GROUP ELE	MODEL 2017MY Sportage (QL)
	NUMBER 118	DATE October 2016
TECHNICAL SERVICE BULLETIN		
SUBJECT: SERVICE ACTION: BCM UPGRADE-FUEL DOOR OPEN LOGIC IMPROVEMENT (SA247)

This bulletin provides information related to the BCM (Body Control Module) software upgrade on 2017MY Sportage (QL) vehicles to improve the fuel door open logic. To install the upgraded logic, the BCM should be reprogrammed using the GDS/KDS download. Additionally, two stickers explaining the new fuel door/door lock logic will be applied to each affected vehicle: one on the instrument cluster and one on the fuel door, as described in this bulletin. Kia is requesting the completion of this Service Action on all affected vehicles in dealer stock prior to delivery. For confirmation that the latest reflash has been done to a vehicle you are working on, verify ROM ID using the tables in this TSB.

This issue number is SA 247.

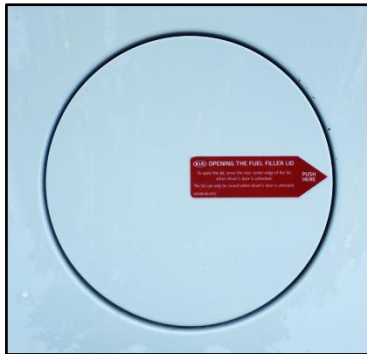
15. Attach the appropriate stickers to the fuel door and instrument cluster as shown.

Make sure to remove the plastic protective film on instrument cluster before installing sticker.
Stickers should only be removed by the customer after delivery.

Fuel Door Location

Instrument Cluster Location
